CO 119 Bikeway

Concept Design Validation Memo

Draft

Submitted to:
Boulder County
Transportation Department

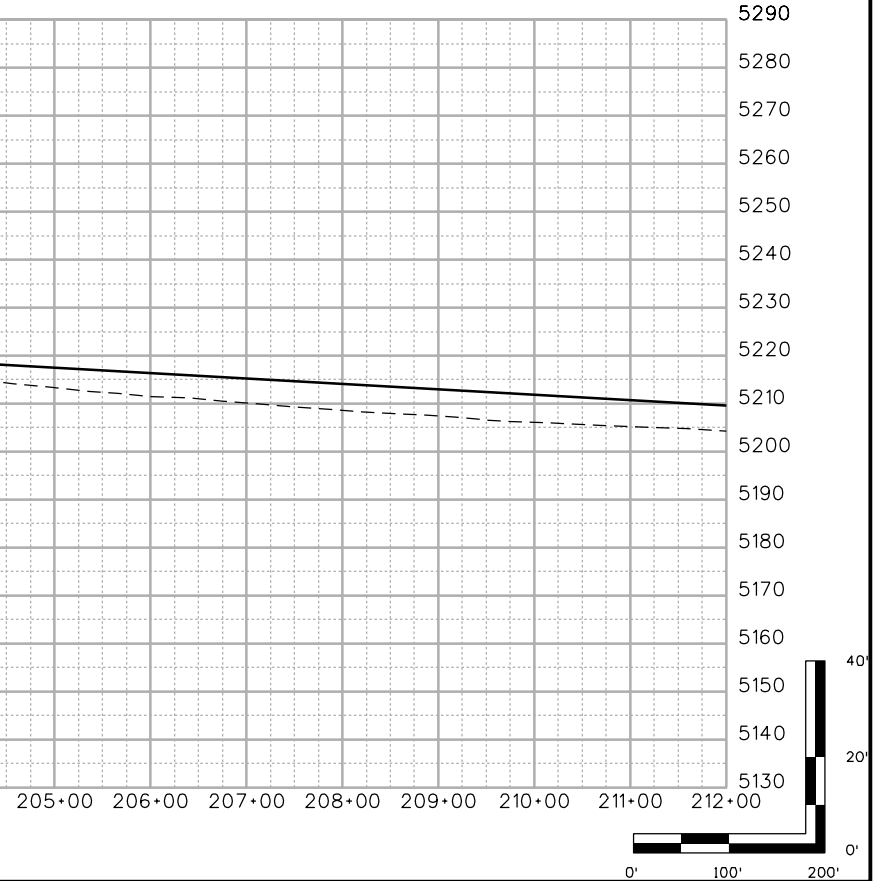
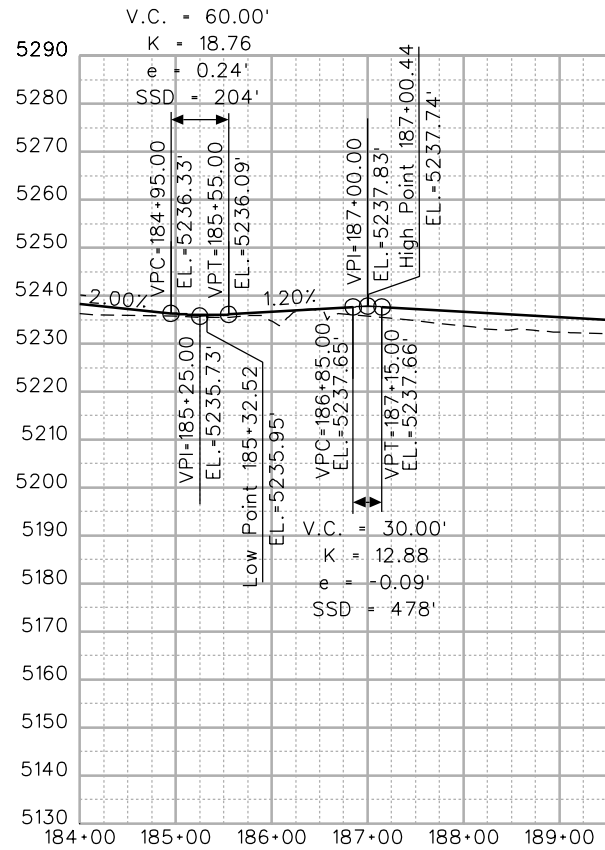
ALIGNMENT GOOD AS-IS. TERRAIN IS FLAT AND WIDE OPEN WITH NO TREES OR WETLANDS

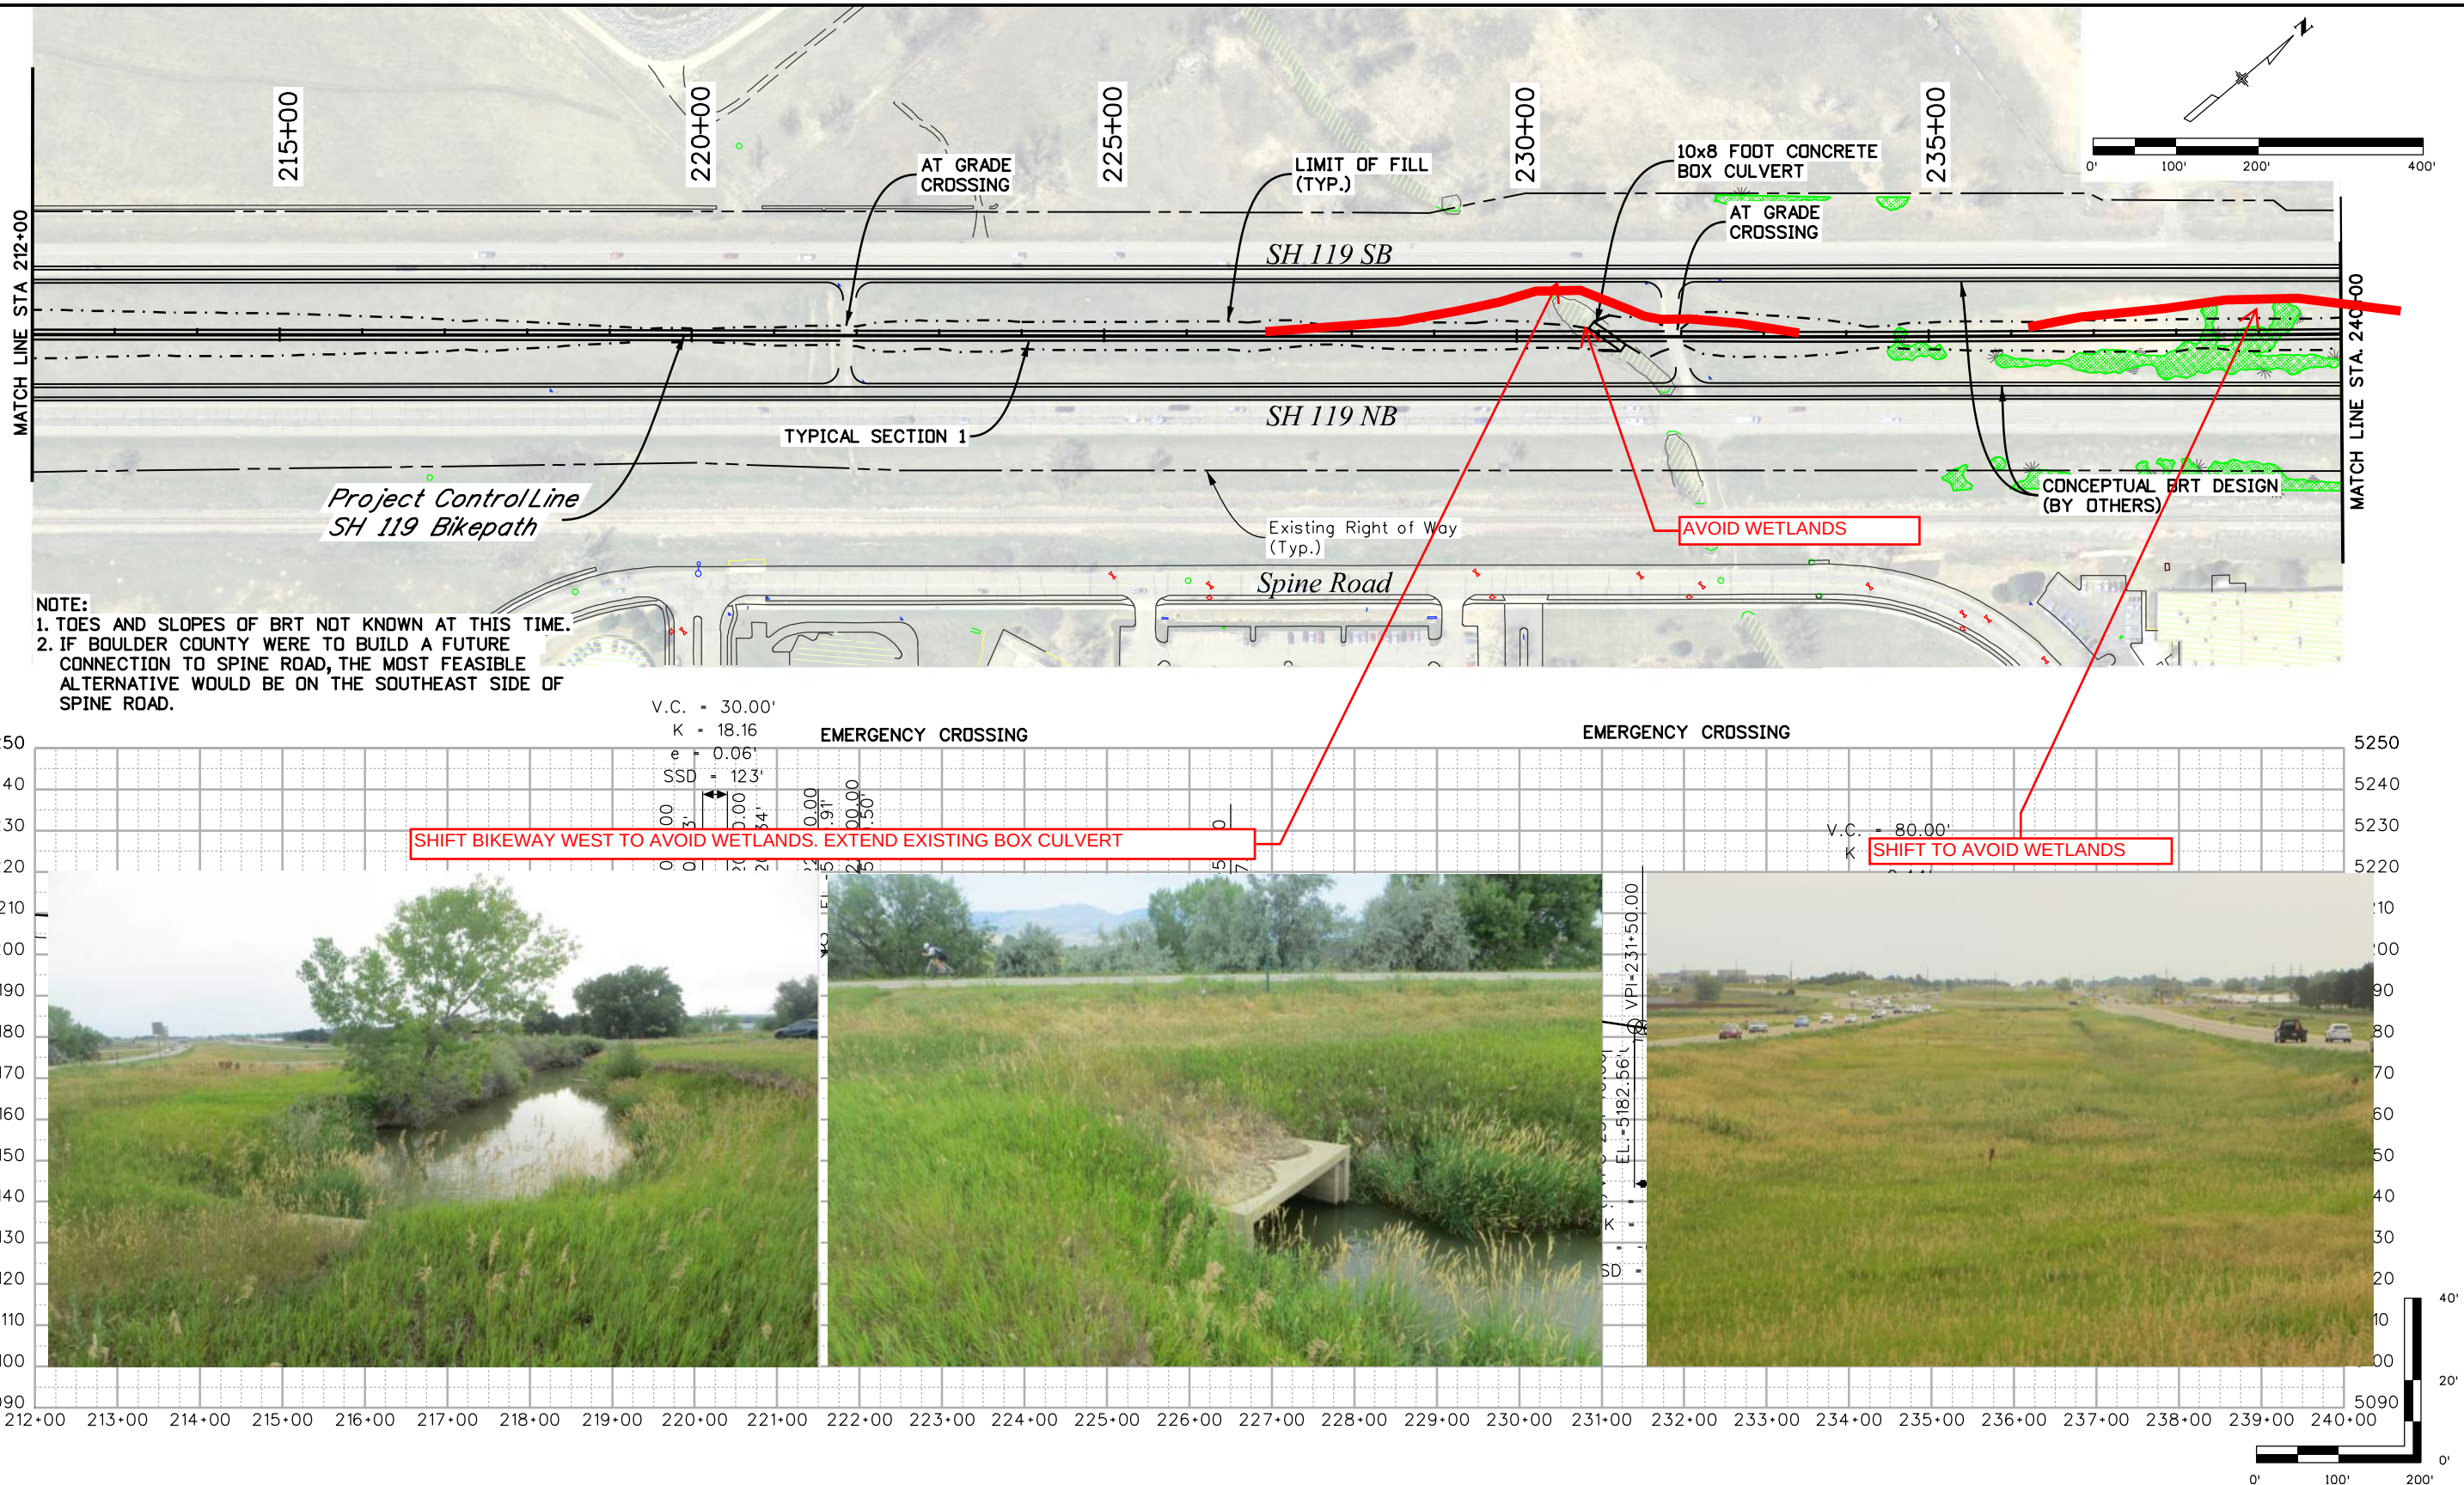
SHIFT BIKEWAY WEST TO AVOID WETLANDS. EXTEND EXISTING BOX CULVERT

SHIFT TO AVOID WETLANDS
